August 11, 2025

National Forests in North Carolina
ATTN: Objections Coordinator
160A Zillicoa Street
Asheville, NC 28801

On behalf of MountainTrue, the Center for Biological Diversity, and Defenders of Wildlife (“Objectors”), the Southern Environmental Law Center submits the following Objection to the Draft Decision Notice and Finding of No Significant Impact for the Crossover Project (“the Project”) published on June 12, 2025,¹ by the responsible official, J. Brian Browning, the District Ranger for the Cheoah-Tusquitee Ranger District of the Nantahala National Forest. This Objection is timely.

Figure: Slopes over 40% (orange) and over 70% (red)

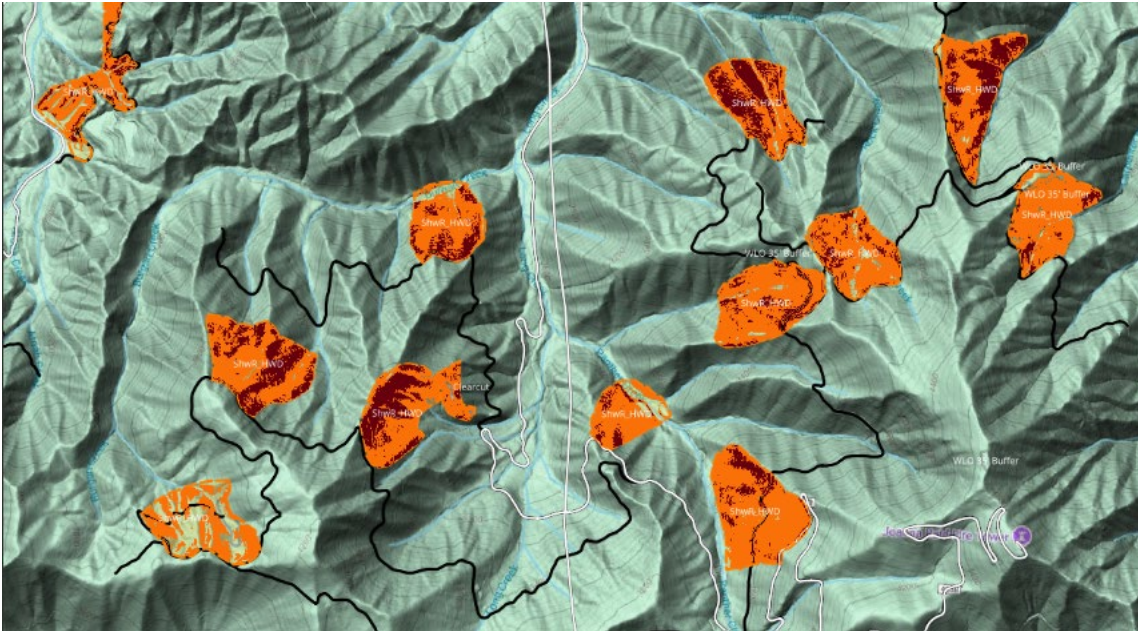
The stands in this project are exceptionally steep. As the figure below shows, many stands are over 40%, and large portions of stands are over 70%. As a result, logging in this area poses exceptional risk. Several legal and analytical responsibilities flow from this risk, and although the Forest Service has improved its analysis from the draft stage, it has not met all its obligations.

First, we argued in our comments that the Forest Service should specify harvest method and clarify access implications of the chosen methods for each stand. The Final EA improves upon the Draft by specifying the harvest type for each stand and commits to cable yarding for stands with steep slopes—for all but one stand. The Final EA does not carry this site-specific analysis through, however, to update its water quality determination.

The Forest Service determined that while all other stands with a sustained slope of over 40% will utilize cable yarding, a ground-based system is more appropriate for Stand 113/10. While we appreciate the Forest Service's attempt to minimize access road building and other resource concerns, deciding between ground or aerial logging methods was the wrong question to ask here. If the cable yarding method required for such steep slopes is unfeasible, the stand should simply be ineligible for commercial harvest, at least to the extent that ground-based harvest would require stacking of skid trails (which of course the Plan and its analysis assume will be avoided). The Forest Service's vague reference to soil disturbance modeling and blind faith in BMPs does not sufficiently demonstrate that ground-based logging will be as protective as aerial methods. When steep slope stands require treatment to promote desired future composition, such as Stand 113/10, other less impactful, non-commercial treatment options like slash/burn/plant are available.

The Plan's requirement for cable yarding for commercial harvest on steep slopes cannot be merely a suggestion inviting a work-around. If it is unworkable, the stand cannot be commercially harvested. We would like further discussion during the objection process about whether stacked skid trails can be prohibited in this stand, perhaps with non-commercial inclusions to cut white pine that cannot be reached by ground-based equipment subject to that limitation.
